Dawn Mining Company Uranium Millsite

TECHNICAL EVALUATION REPORT

License Amendment Request to Extend Midnite Mine Sludge Disposal into Tailings Disposal Area 4 (TDA-4)

January 2009

FIGURE 1
 SEQUENCE OF OVERLINER PLACEMENT IN TDA-4

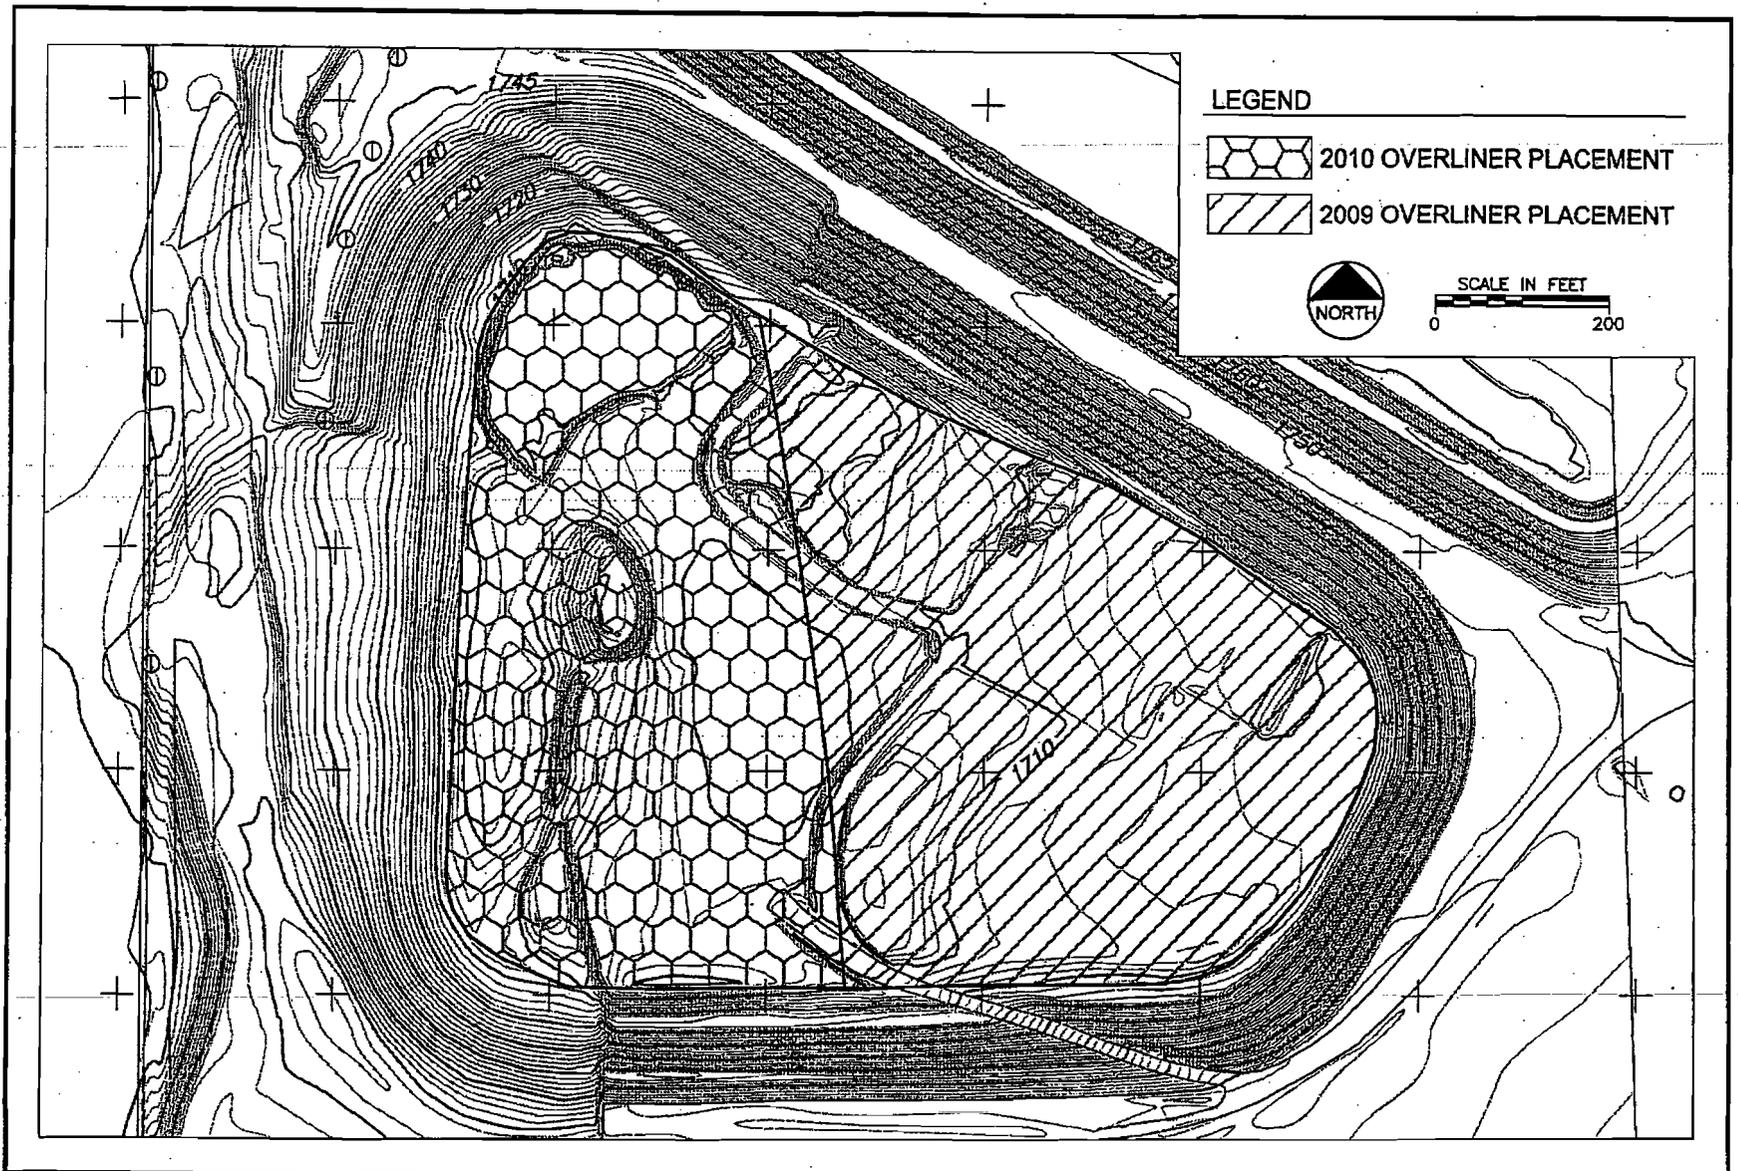
The current open area on the bottom of TDA-4 is approximately 15.1 acres. Of this total, the eastern portion is approximately 7.8 acres with approximately 75% of this area covered and stabilized with fill material excavated from the mill and stockpile areas in 2003 (Figure 2, Area 1). The western portion of TDA-4 is approximately 7.3 acres and will require fill to be placed to cover and stabilize currently uncovered tailings slimes. This activity is scheduled for 2009. The current topography of TDA-4 is shown on Figure 1.

FIGURE 2
 DISPOSAL AREAS IN TDA-4

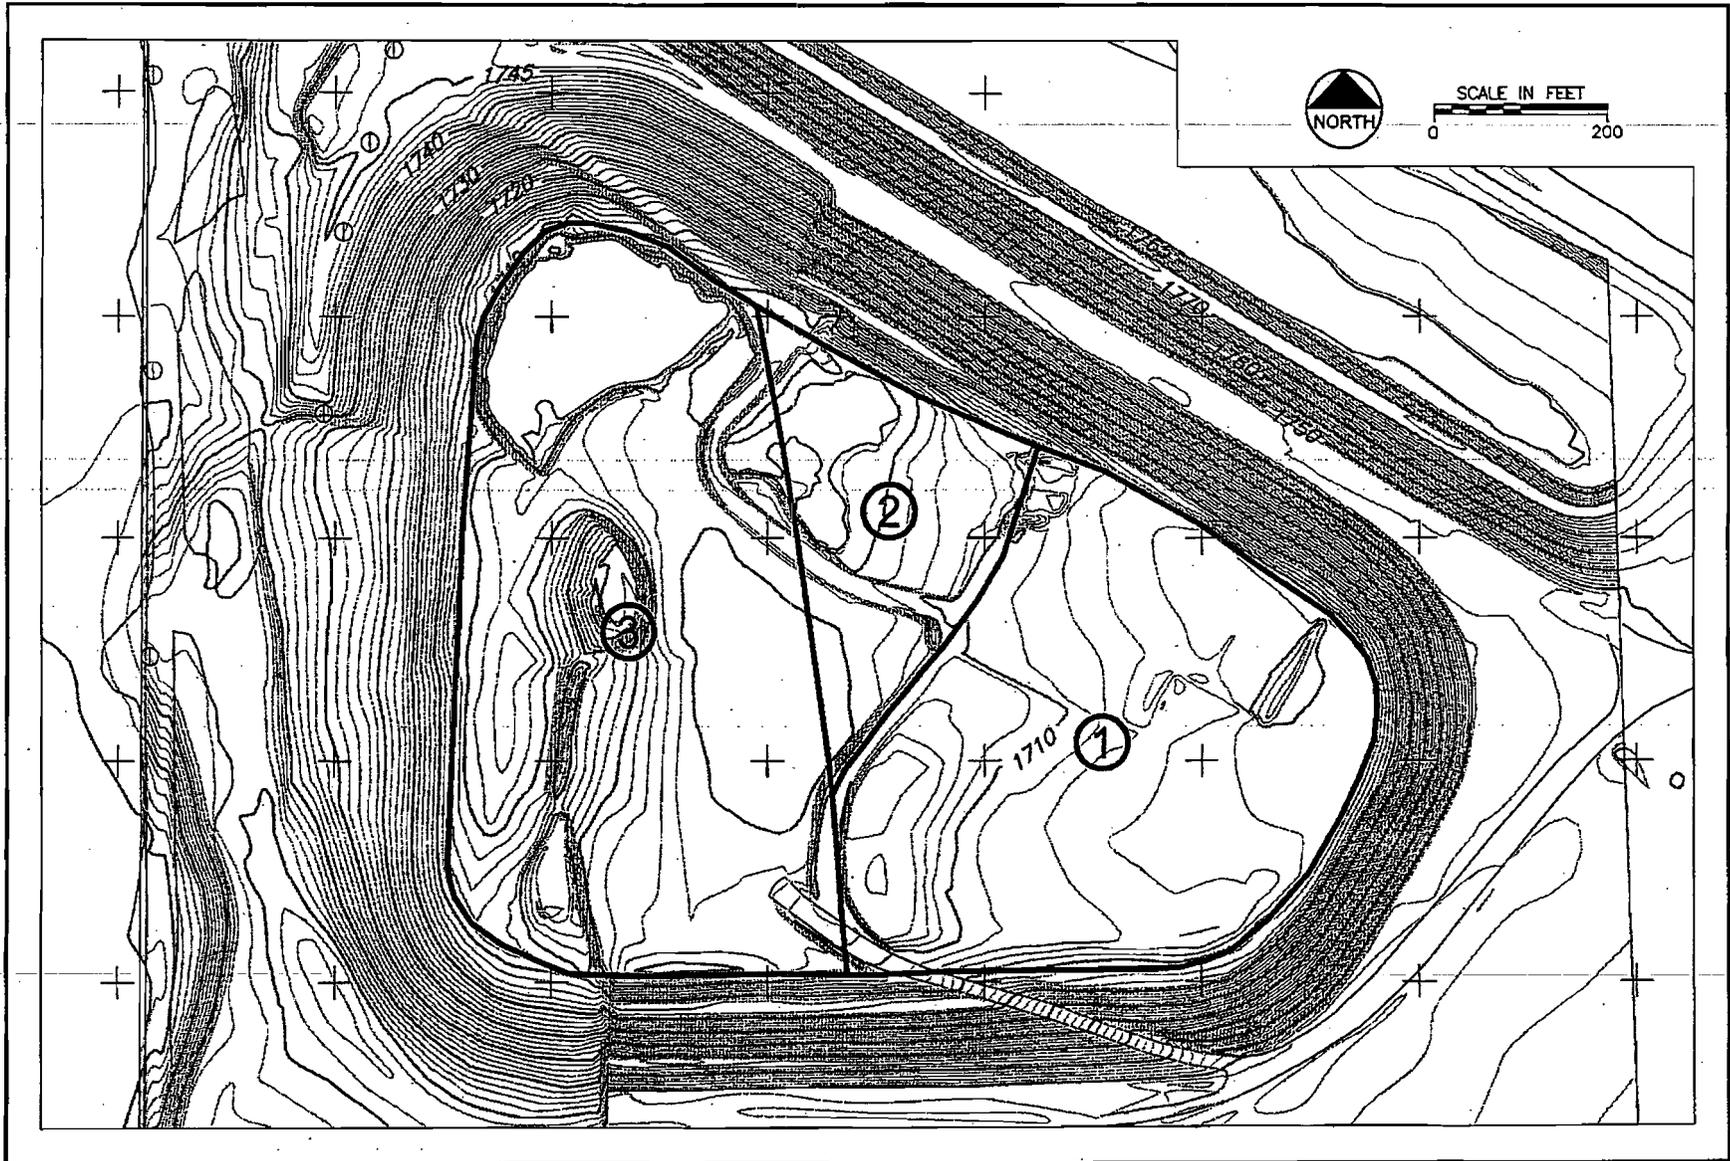
The eastern portion of TDA-4 is the area in which sludge has been placed for disposal since 2001. Approximately 25% of this area will require additional fill material and preparation for overliner placement in September/October of 2009 (Figure 2, Area 2). Sludge can be disposed in the eastern portion of TDA-4 until grading for the overliner begins (Figure 2, Areas 1 and 2). At that time sludge disposal would continue in the western portion of TDA-4 (Figure 2, Area 3). Relocating sludge disposal to the western portion of TDA-4 will not impact TDA-4 closure activities or pose any additional human health risk. The volume of sludge that would be disposed in the eastern portion of TDA-4 in 2009 is estimated to be approximately 45,000 cubic feet (1,667 cubic yards), only a small portion of the total fill required.

The western portion of TDA-4 currently includes filled and stabilized surfaces and unstabilized areas of slimes and standing water. Stabilization activities in the western portion of TDA-4 during 2009 will cover all surfaces resulting in a significant expansion in the stabilized surface area that will allow vehicle and truck traffic and provide additional areas for disposal of the estimated 1,667 cubic yards of sludge during the summer of 2010 (Figure 2, Area 3).
